ATTACHMENT 5A

Emergency Plan Marked-up Pages – LaSalle Station

Exelon Standardized Emergency Plan EP-AA-1000
and
Emergency Plan Annex EP-AA-1005

Affected Pages – Marked-up

Figure B-1a: Exelon Overall ERO Command Structure

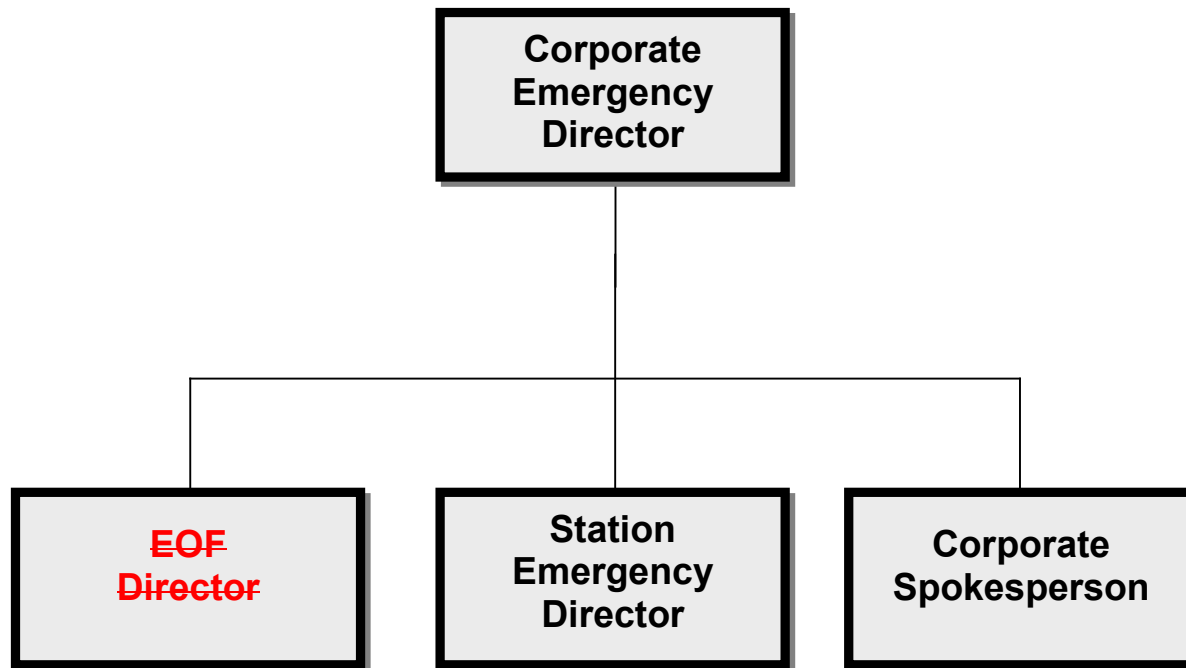
ERO staffing tables contained ~~within the station specific Annexin Appendix 5~~, lists the key positions of the ERO ~~and the supporting positions assigned to interface with federal, state, and county authorities~~. Figures B-1a through B-1d illustrates the overall emergency response organization. Section B.5 discusses specific responsibilities and the interrelationships for key positions.

Figure F-3: NRC Communications for Nuclear Response

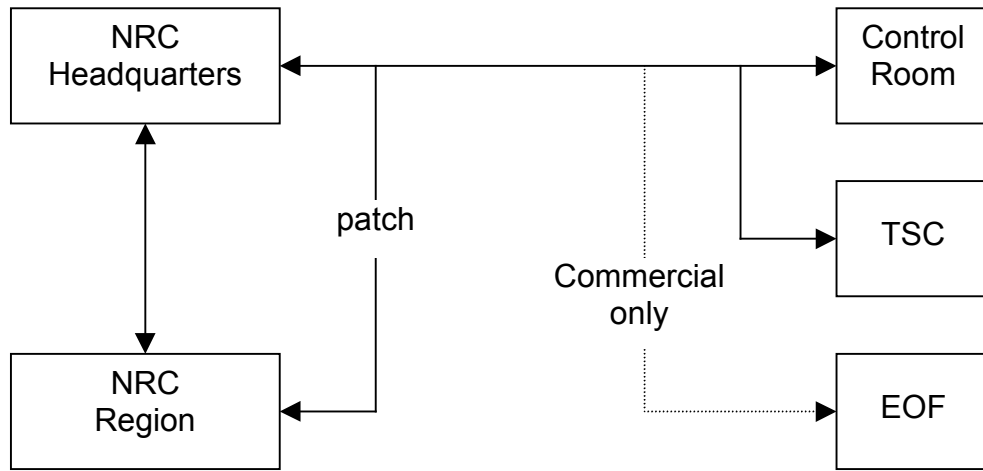
~~Health Physics Network (HPN): There also exists a separate dedicated telephone between the NRC, the TSC, and EOF for conveying health physics information to the NRC as requested or as an open line.~~

NOTE: ENS ~~and HPN~~ circuits may use the Federally maintained system, company tie lines or PBX as dedicated primary communications systems and have commercial backups.
